Process Change Notification (PCN)

PCN #: 082625-2

PCN Title: Correct DFN5060-C POD

Table 2. Package Dimensions

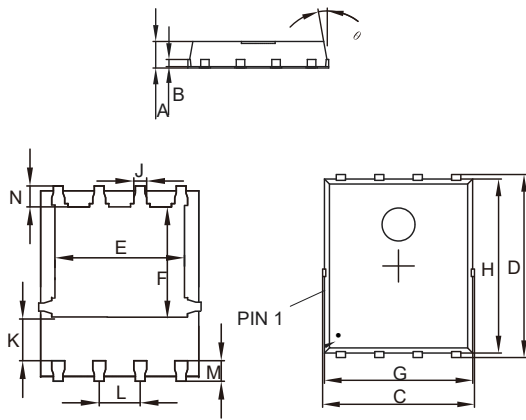
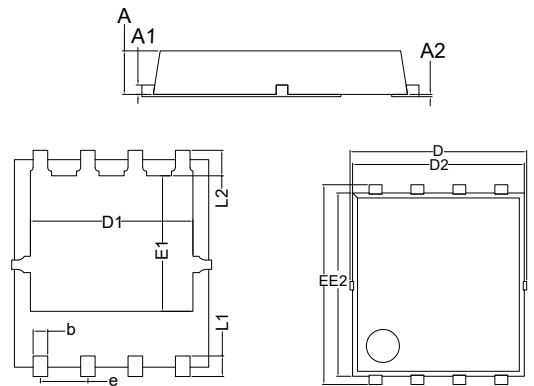
Notification number:	082625-2
Notification date:	26 Aug 2025
Proposed implementation date:	26 Aug 2025
Product type affected:	Please refer to table 1 & table 2 in Appendix 1.
Change Category	Correct DFN5060-C POD
Change Classification	Typo
Change description:	MCC have DFN5060 and DFN5060-C POD, some dimensions are not exactly the same. we detected some devices datasheet link to DFN5060 POD, but actual product is DFN5060-C POD. so we update the datasheet to make sure datasheet matches the product exactly, nothing has changed in the actual product.
Reason for change:	To ensure datasheet accuracy
Deposition of old product	NA
Identification of Changed product:	No changes to product marking
Contact person:	Please contact your respective Account manager (AM) / Inside sales representative (ISR/CSR) if you have further query.
Approved by:	TH Koay (Director of Product) Steve Zhang (Director of Supply Chain) Seaman Wu (Director of Quality) Pamela Cheng (GM & EVP of Sales)

DIMENSIONS					
DIM	INCHES		MM		NOTE
	MIN	MAX	MIN	MAX	
D	0.203	0.218	5.15	5.55	
D2	0.201	0.209	5.10	5.30	
E	0.234	0.242	5.95	6.15	
E2	0.215	0.222	5.45	5.65	
A	0.033	0.041	0.85	1.05	
A1	0.008		0.203		BSC
A2	0.000	0.004	0.00	0.10	
D1	0.167	0.175	4.25	4.45	
E1	0.139	0.147	3.52	3.73	
L1	0.018	0.026	0.45	0.65	
L2	0.027		0.68		BSC
b	0.012	0.020	0.30	0.50	
e	0.050		1.27		BSC
